ADAMSTOWN BOULEVARD PHASE 1

GRANT REF: SDZ22A/0007

INTRODUCTION - PLANNING CONDITIONS

This document is in response to Condition 7 and prepared by McCauley Daye O'Connell Architects.

4.6 HOUSE TYPE H4BD AMENDMENTS TO PLANNING APPLICATION

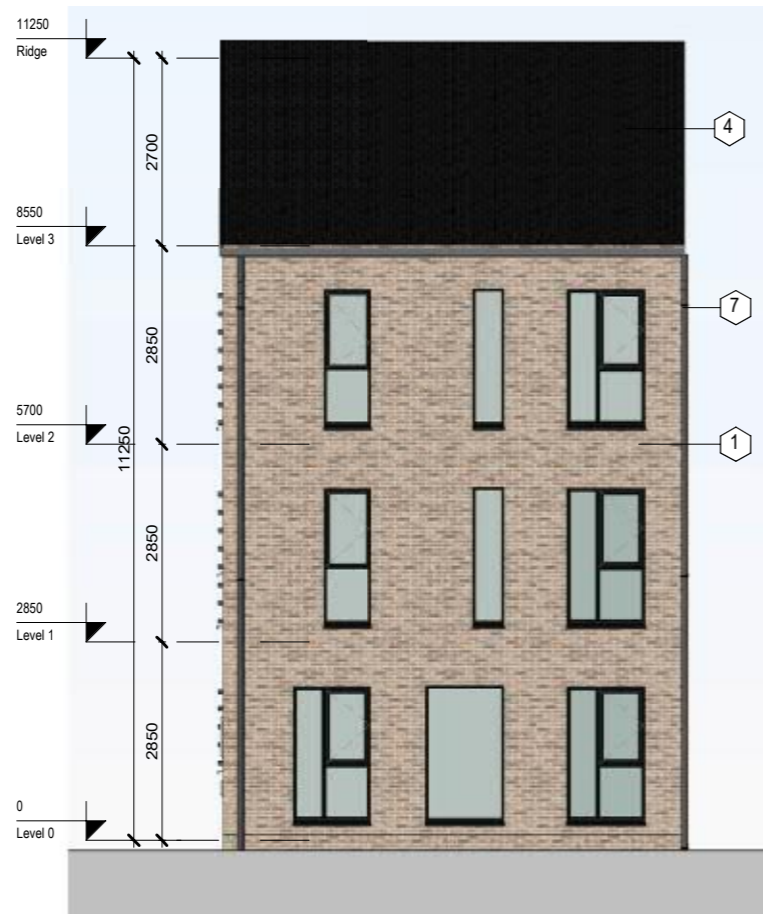
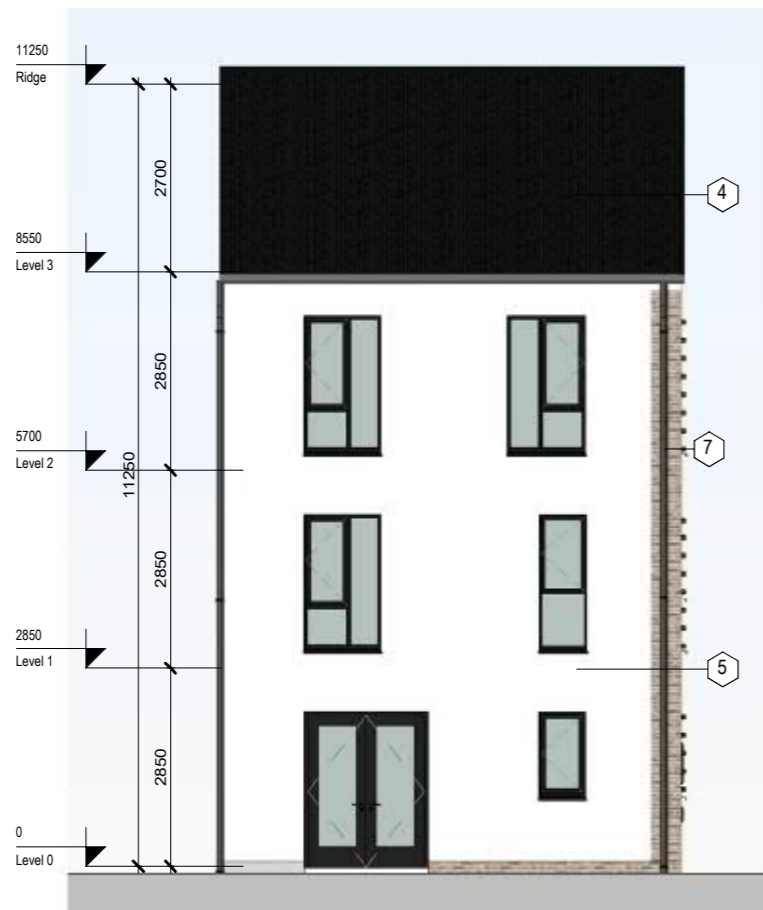
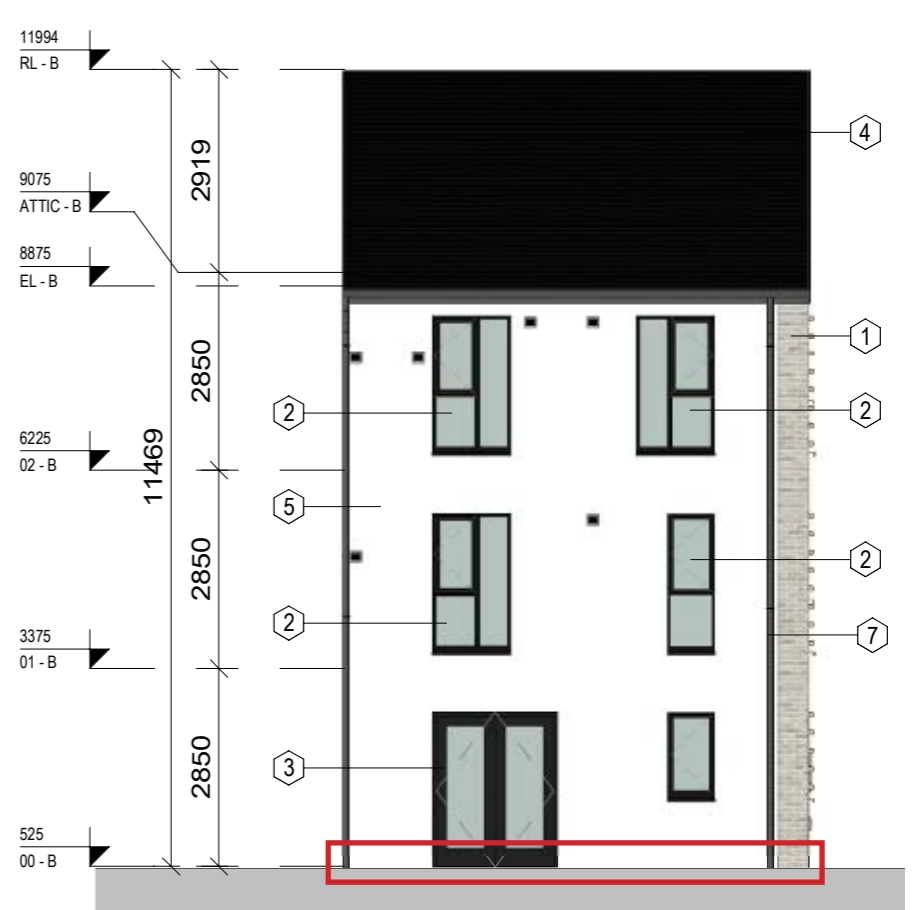
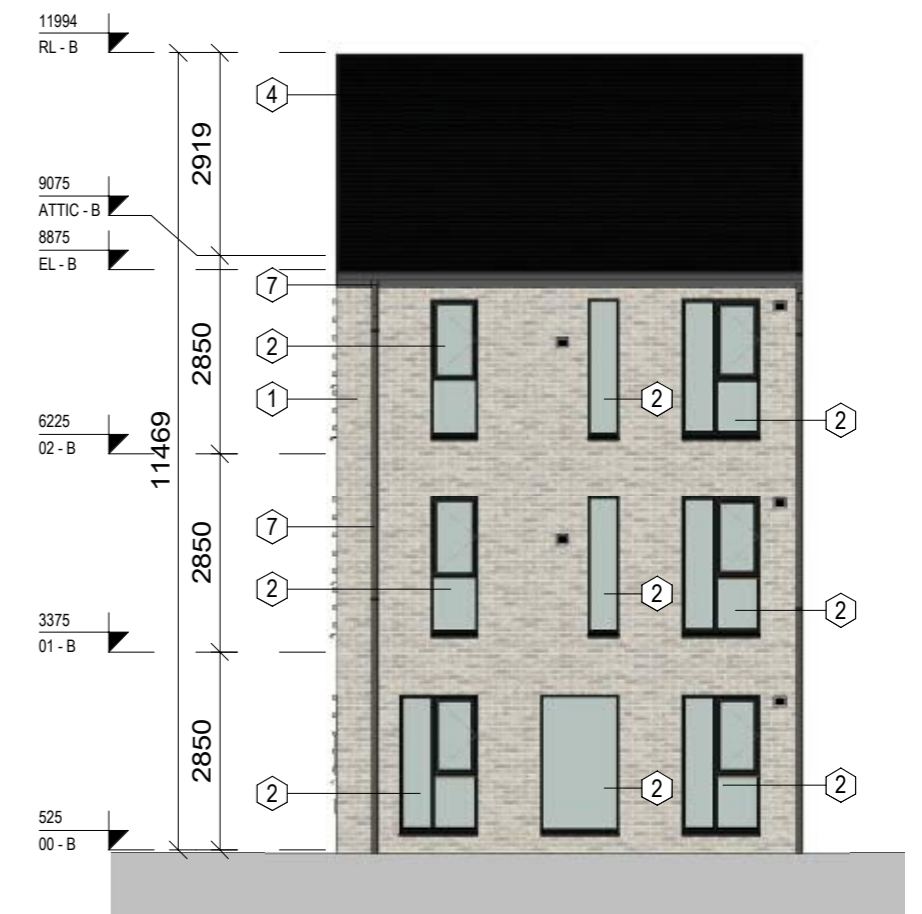
- Plinth to rear removed
- Higher ridge level

4.6 HOUSE TYPE H4BD AMENDMENTS TO PLANNING APPLICATION

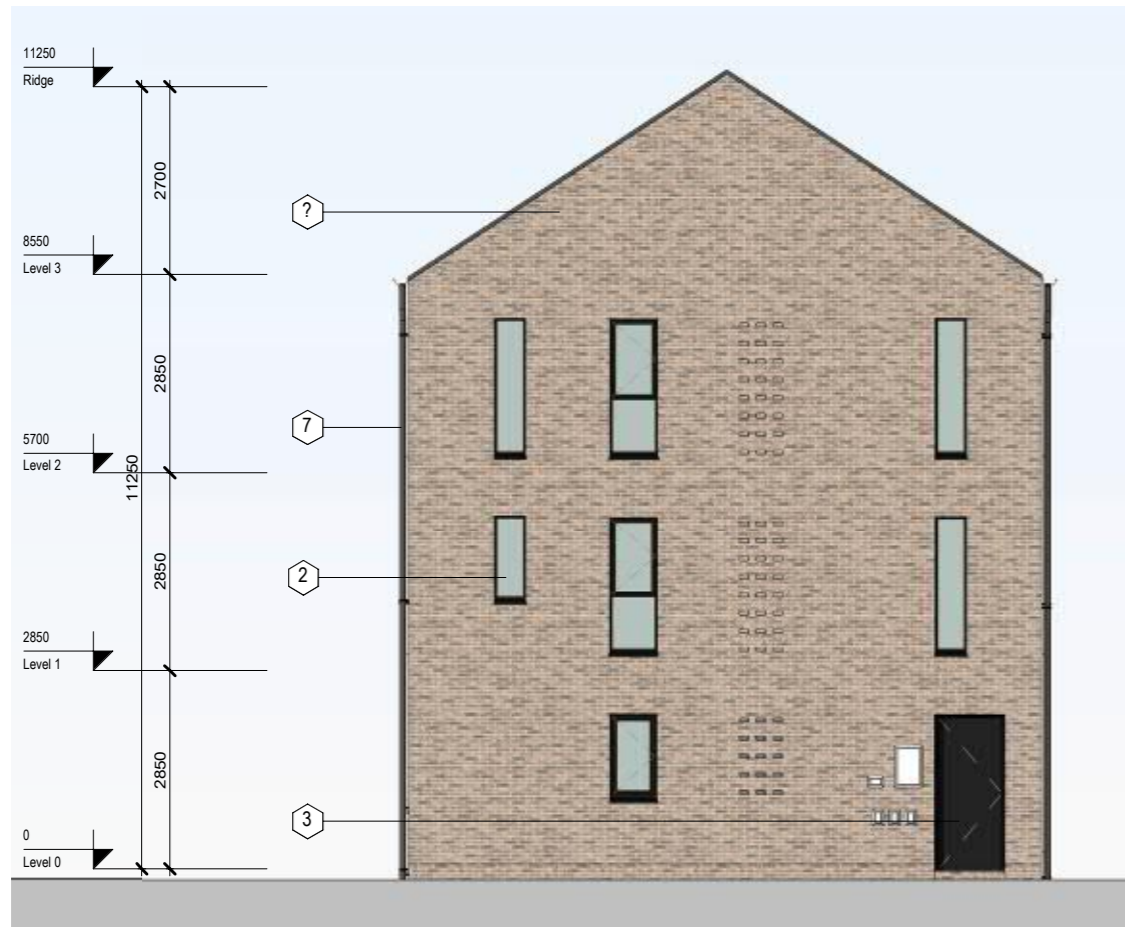
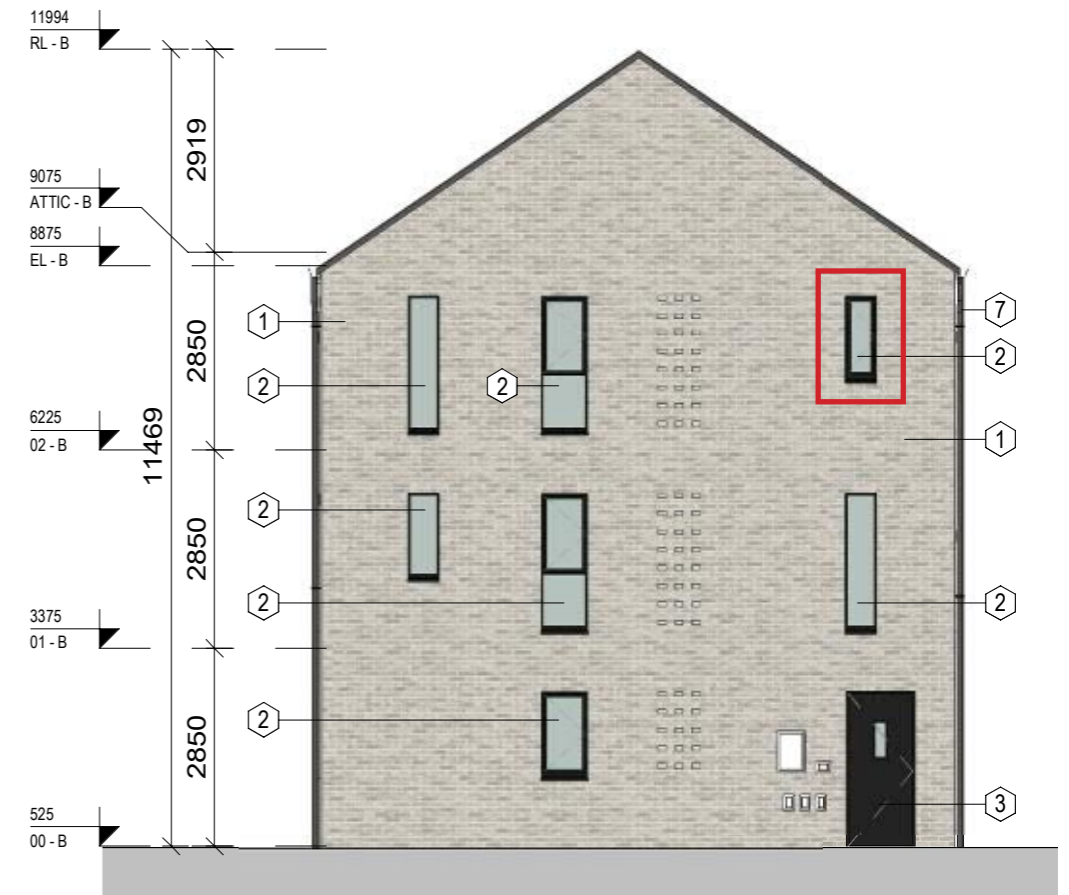
- Window type amended

4.8 HOUSE TYPE H4CB

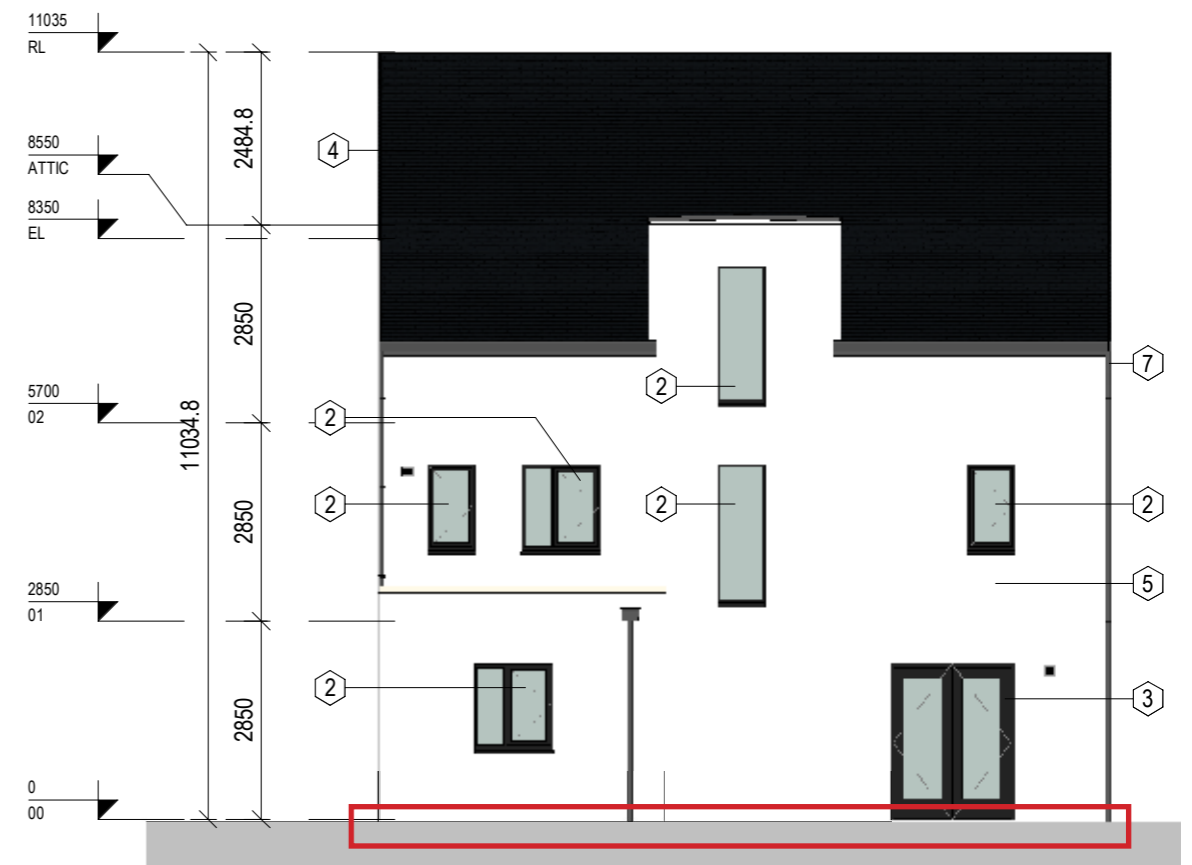
- Plinth to rear removed
- Window type amended
- Entrance door amended
- Lower ridge level

4.9 HOUSE TYPE H4CBF

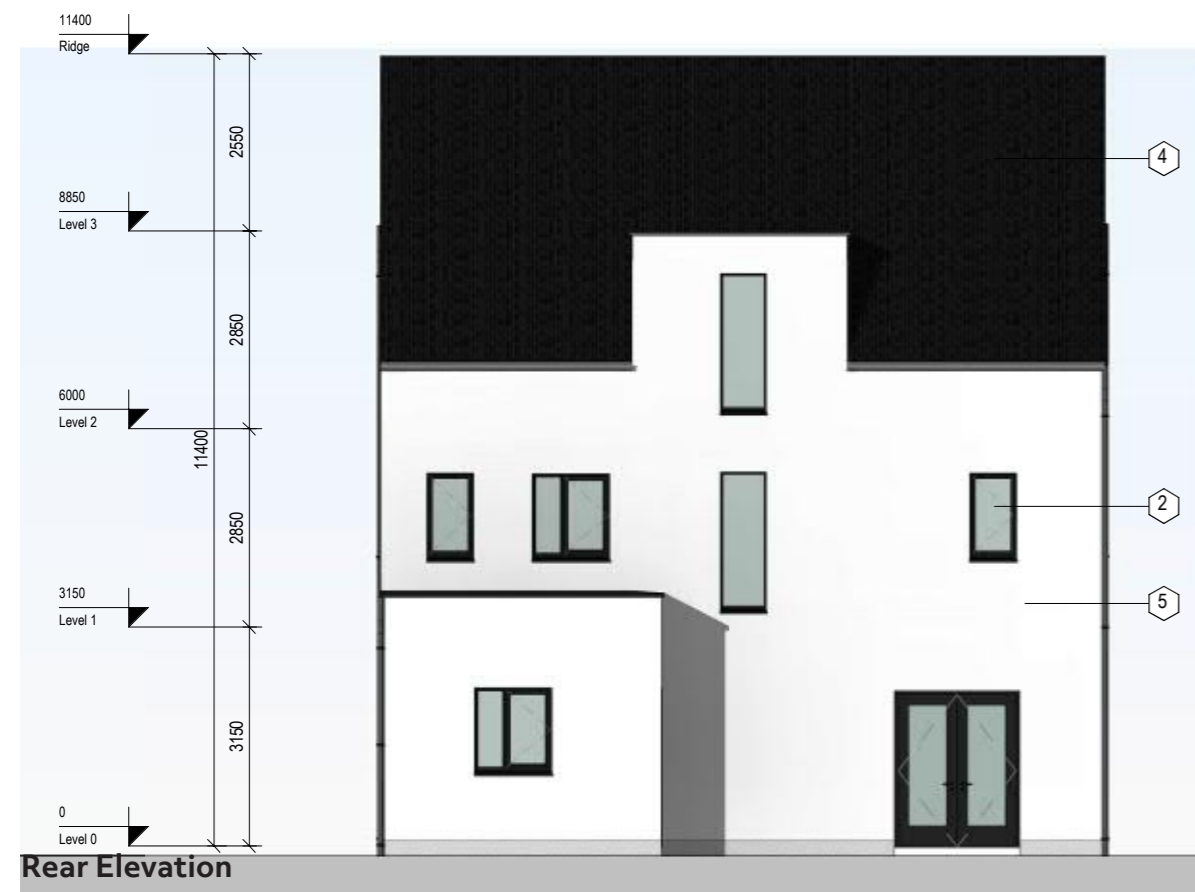
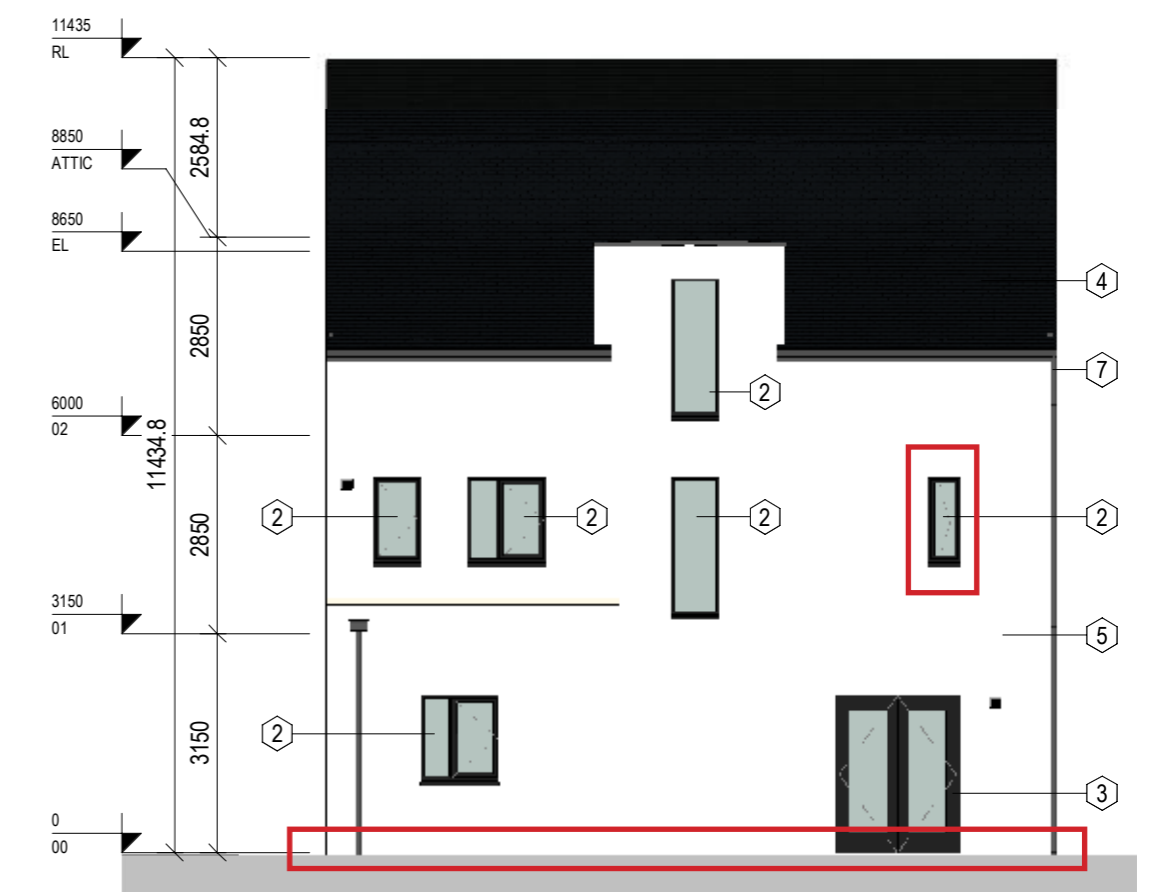
- Plinth to rear removed
- Window type amended
- Front door type amended
- Brick detail introduced
- Higher ridge level

4.10 HOUSE TYPE H4CC AMENDMENTS TO PLANNING APPLICATION

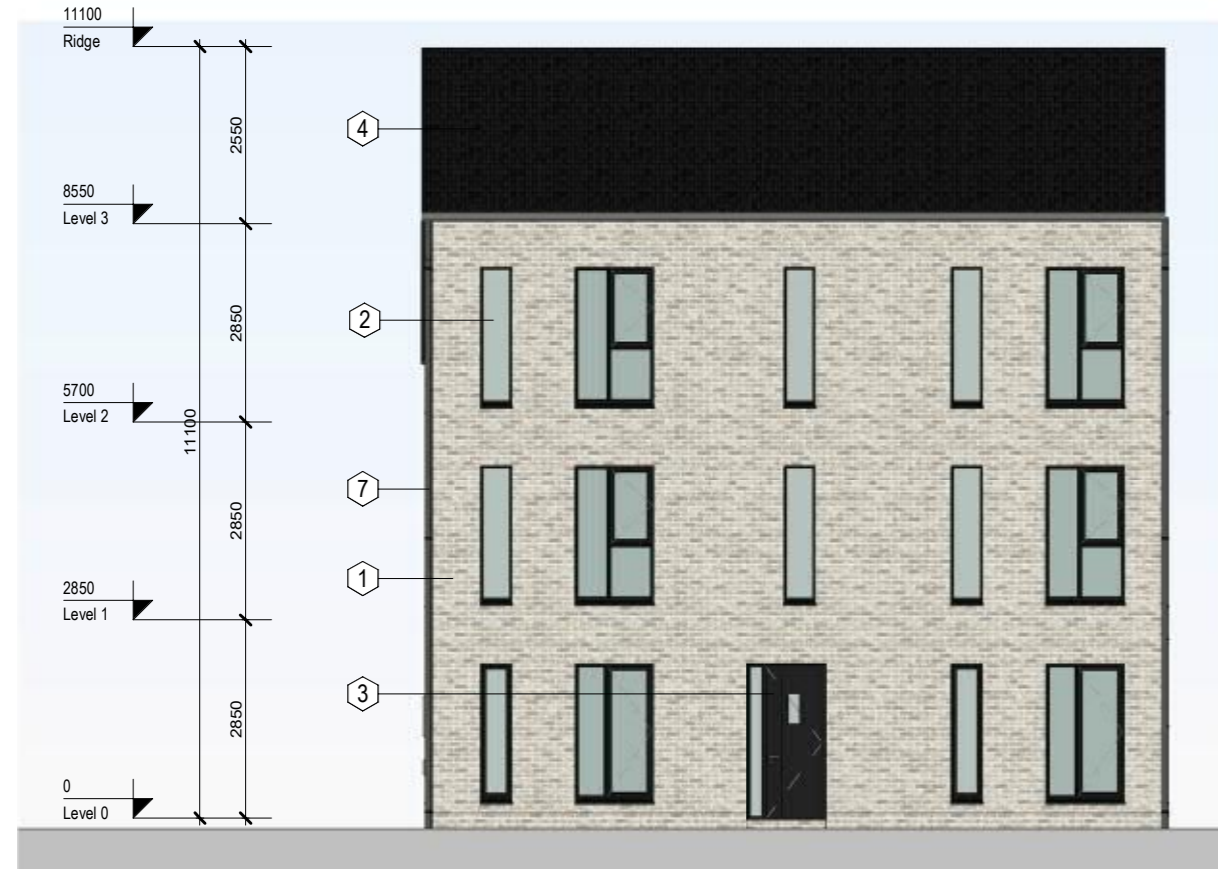
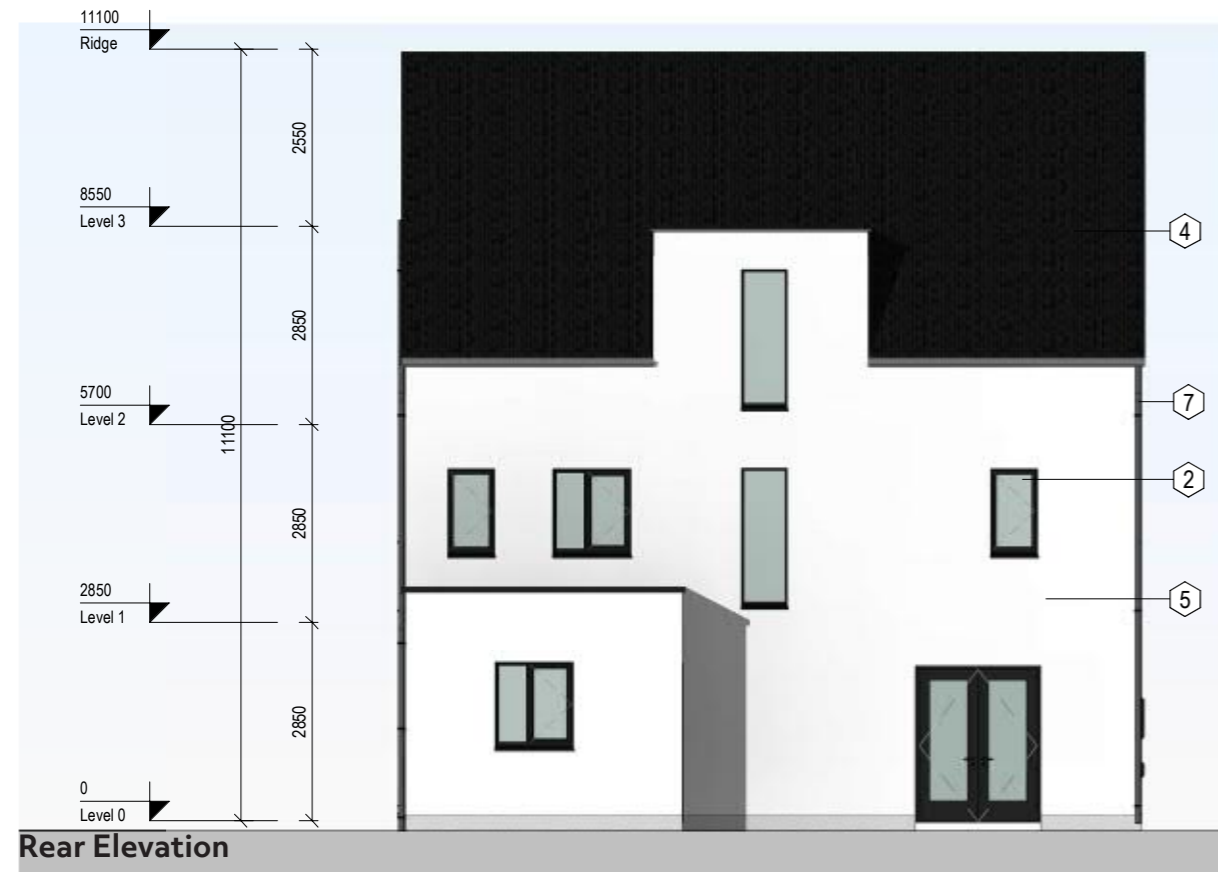
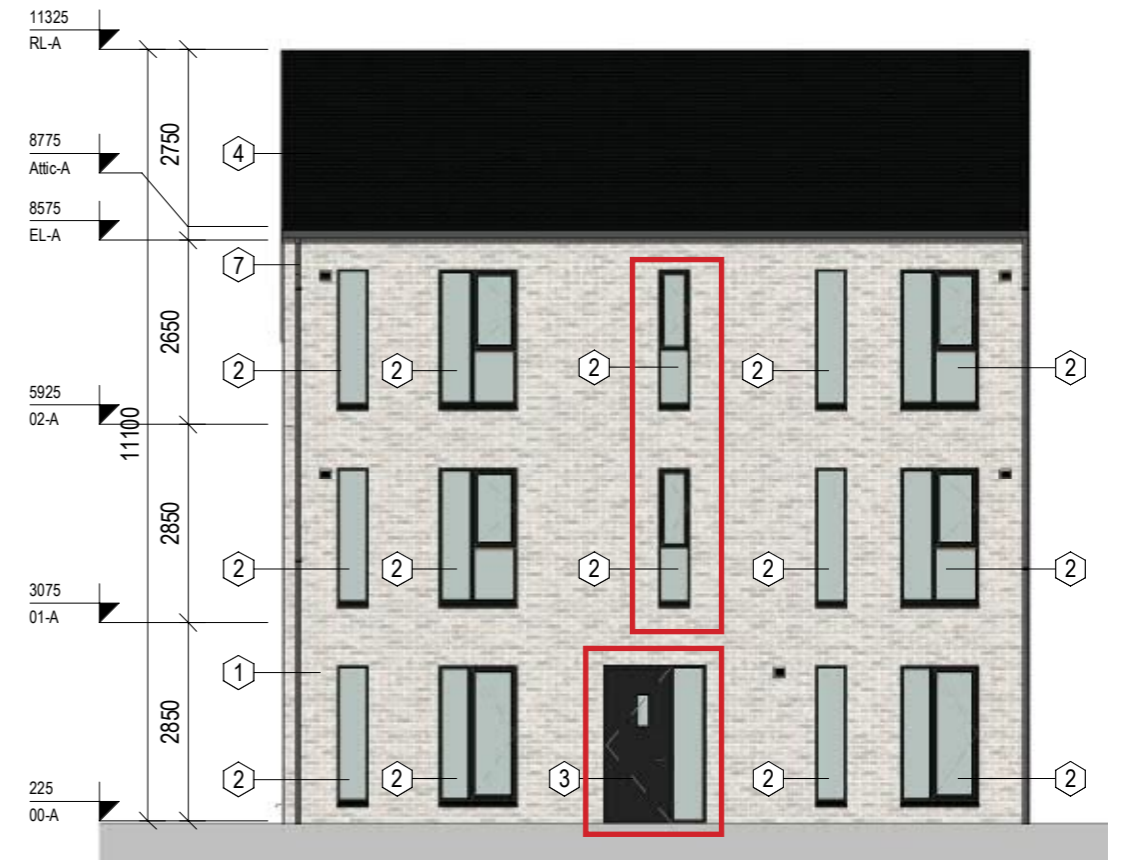
- Plinth to rear removed
- Window type amended
- Front door type amended
- Higher ridge level
